NOTICE OF DECISION

DECISION OF THE PLANNING ADMINISTRATOR

**URBAN GROWTH PRELIMINARY DECLARATION / CLASS 3 SITE PLAN
REVIEW / CLASS 2 ADJUSTMENT / CLASS 2 DRIVEWAY APPROACH PERMIT
/ TREE REMOVAL PERMIT CASE NO.: UGA-SPR-ADJ-DAP-TRP24-02**

NOTICE OF DECISION DATE: April 2, 2024

DRAWING
C1.4
JOB NUMBER
3416.0000.0

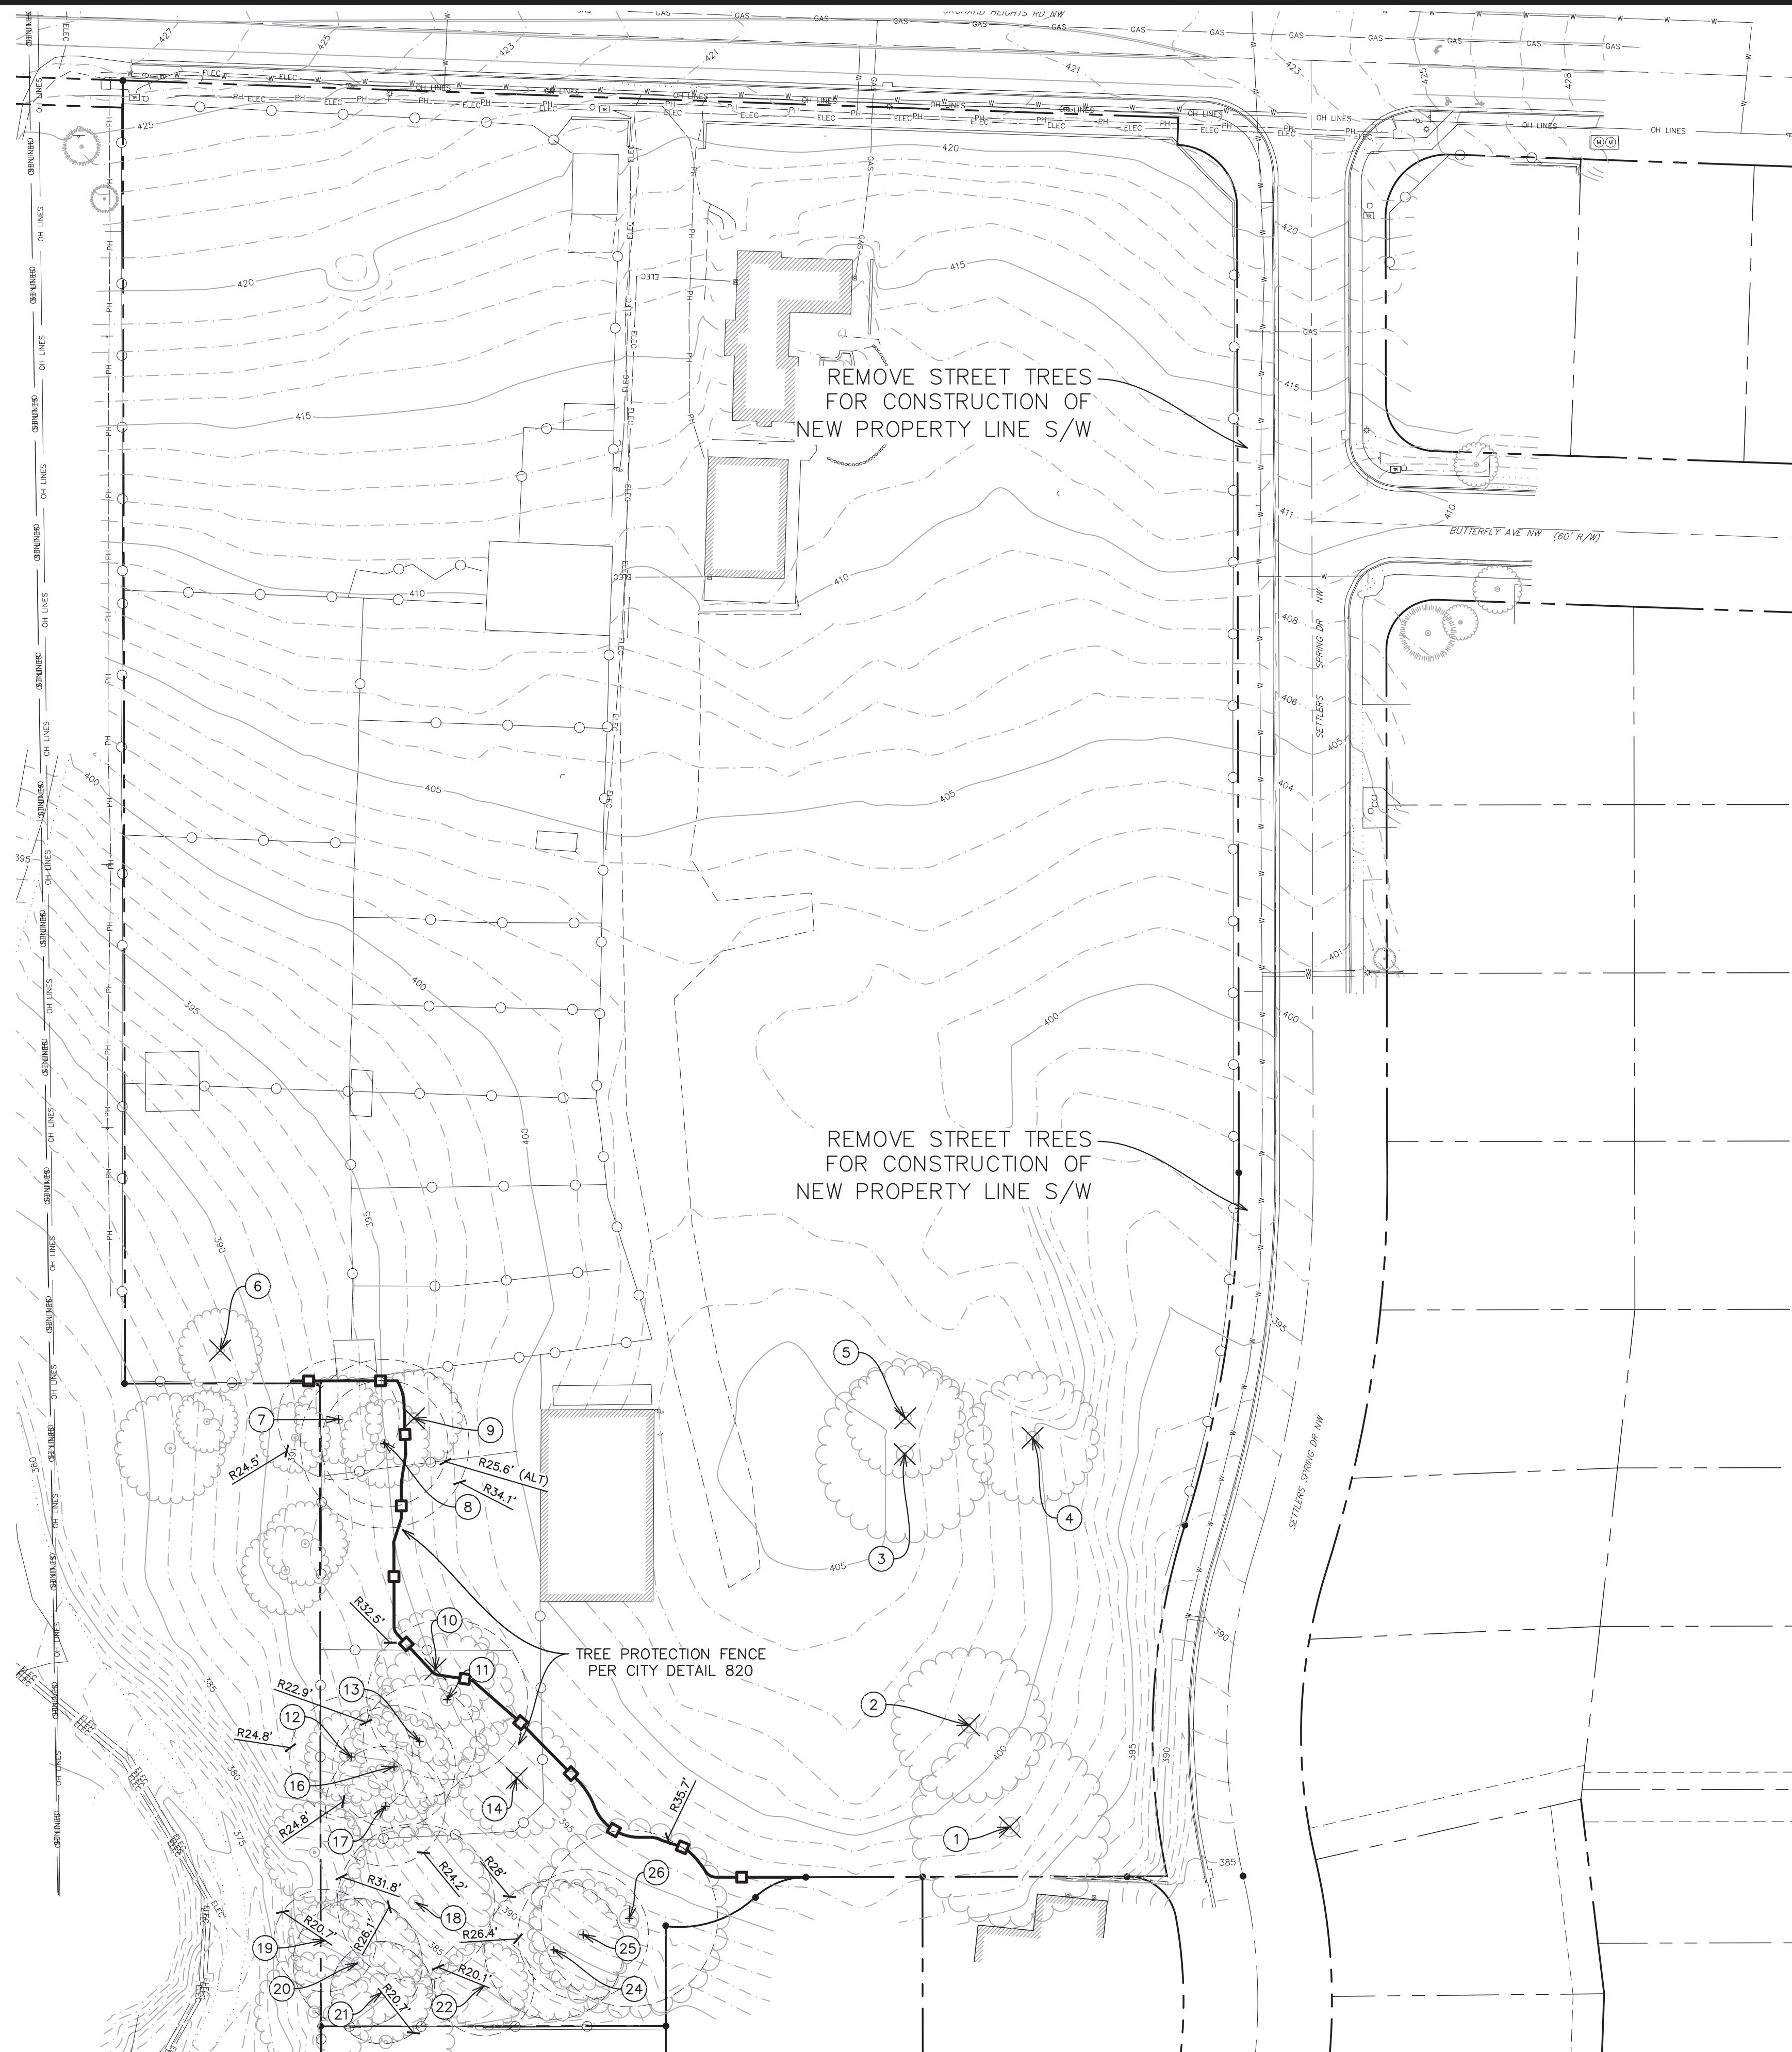
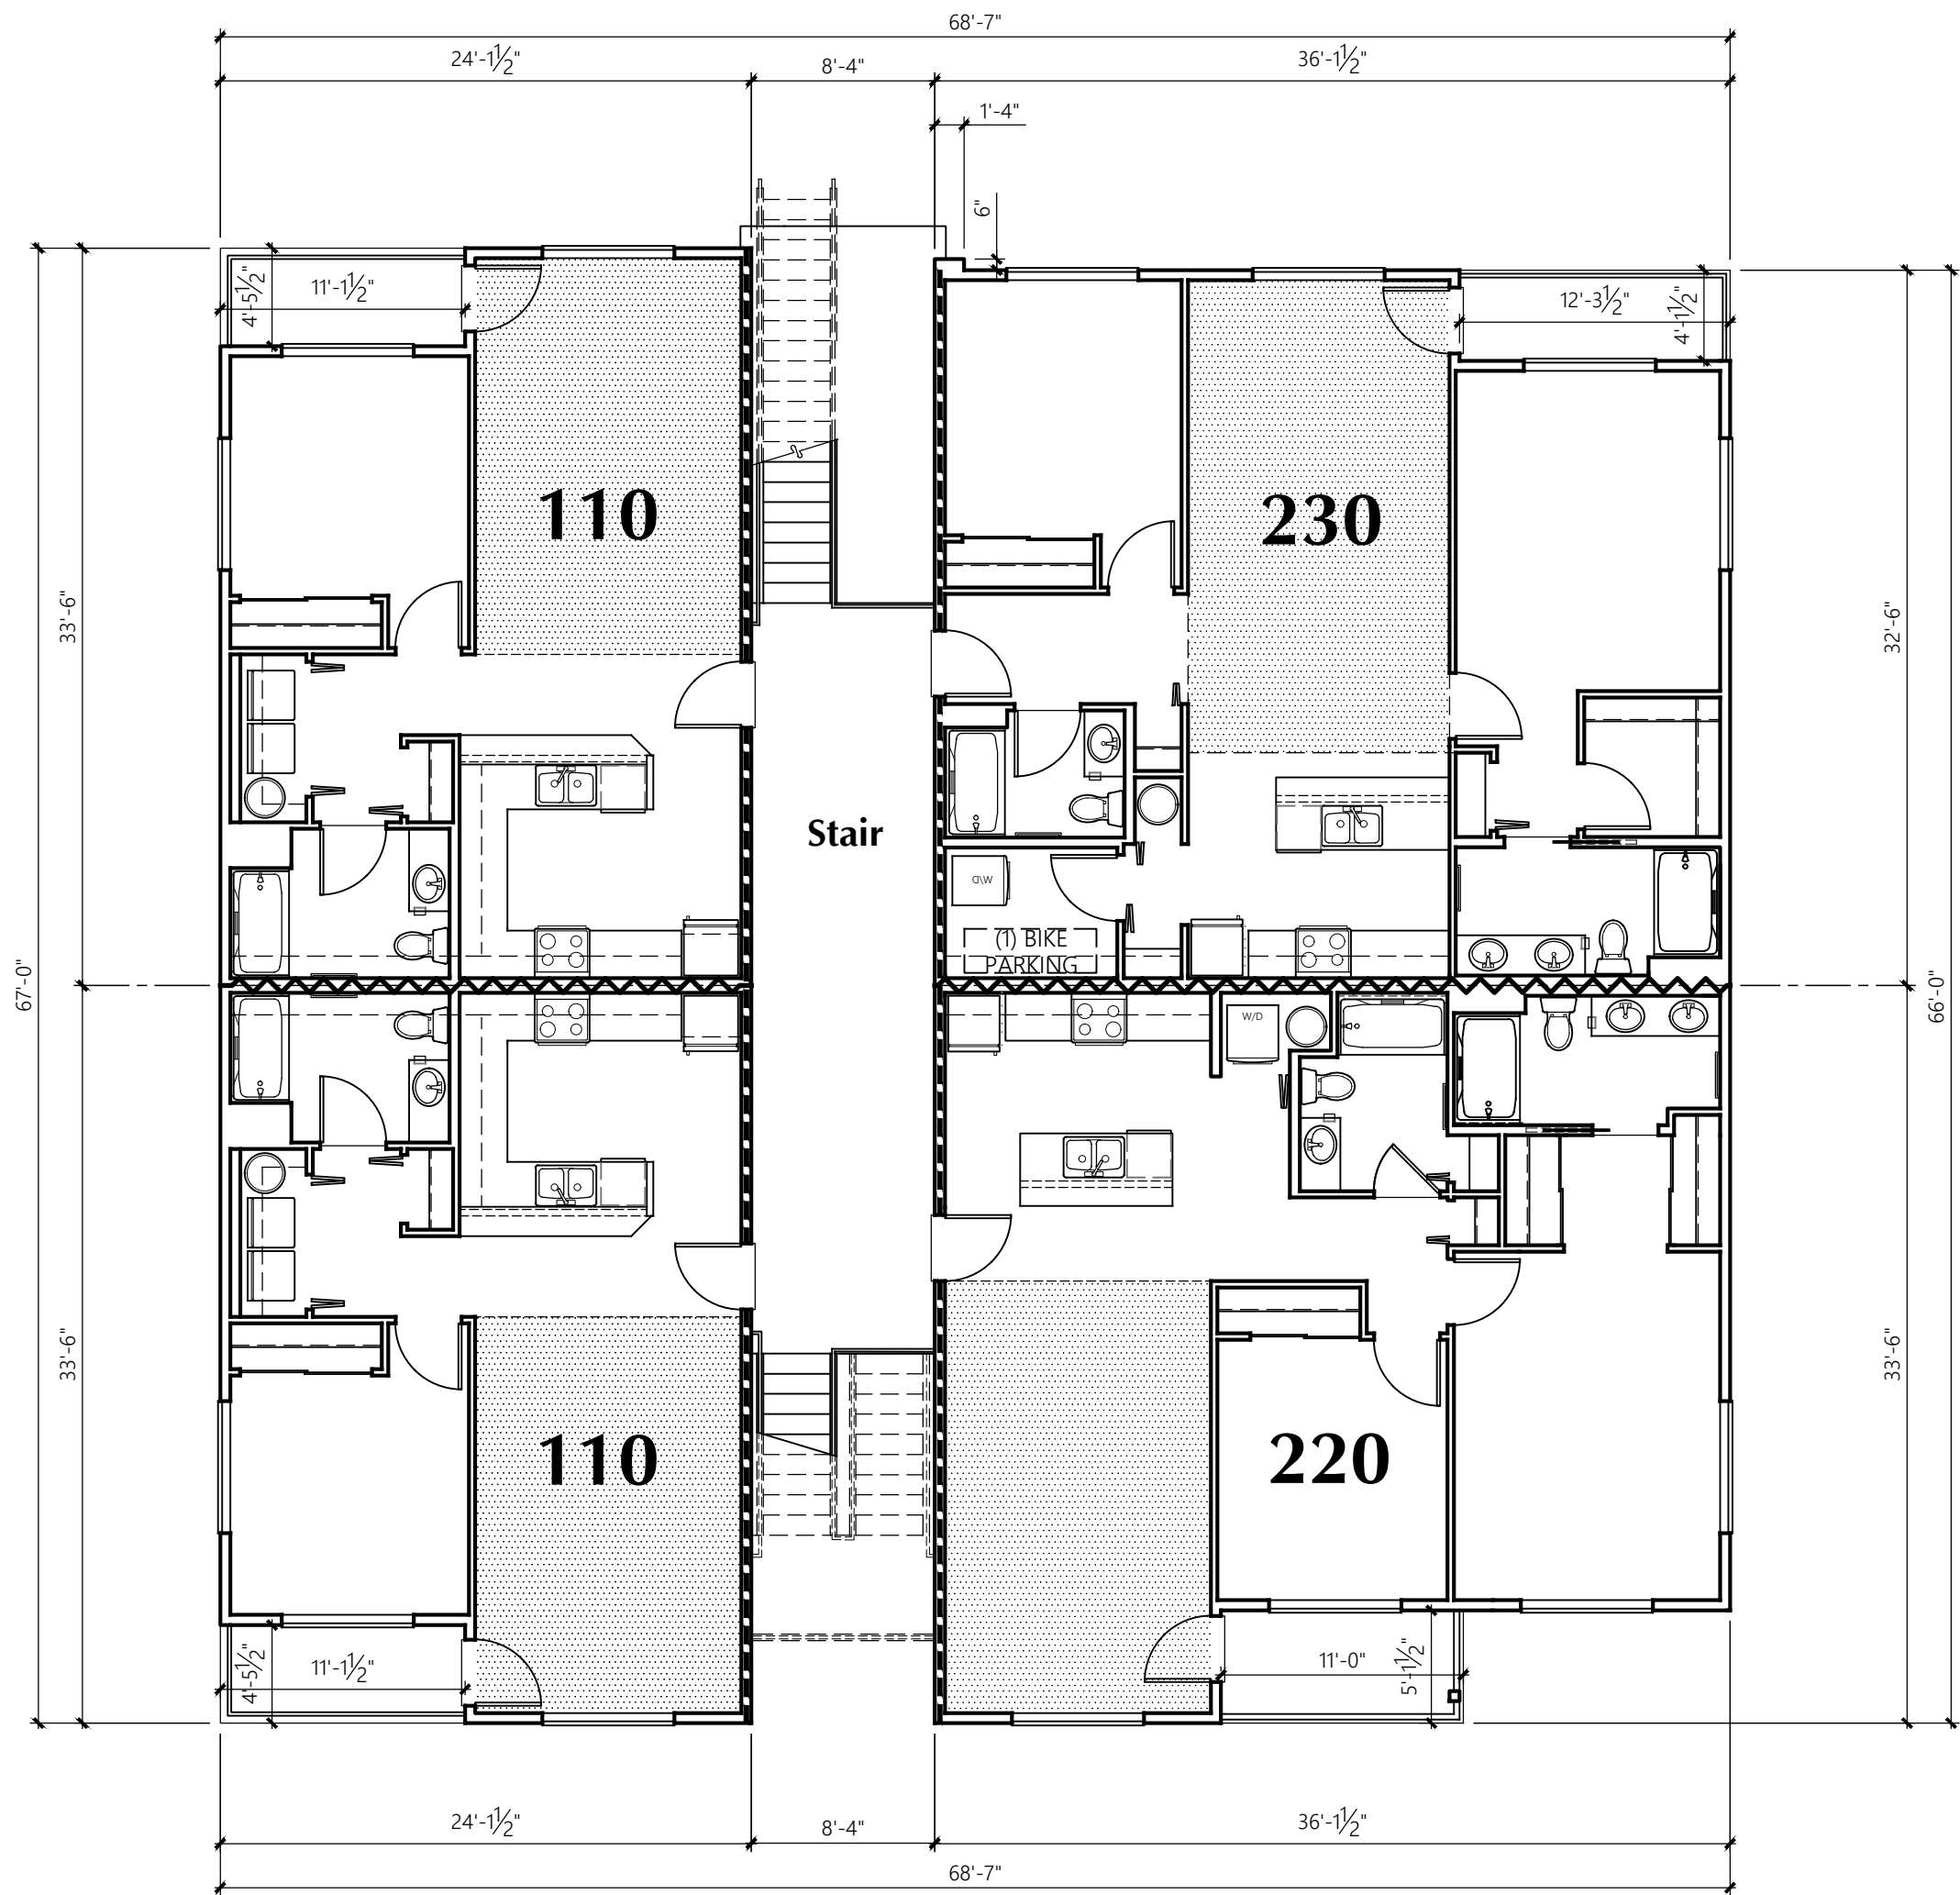
- Condition 3:** The applicant's site plan shall either be revised to demonstrate compliance with the protection measures during construction in SRC 808.046 for Trees 8 and 11, or the applicant may apply for a Tree Removal Permit to remove these trees.
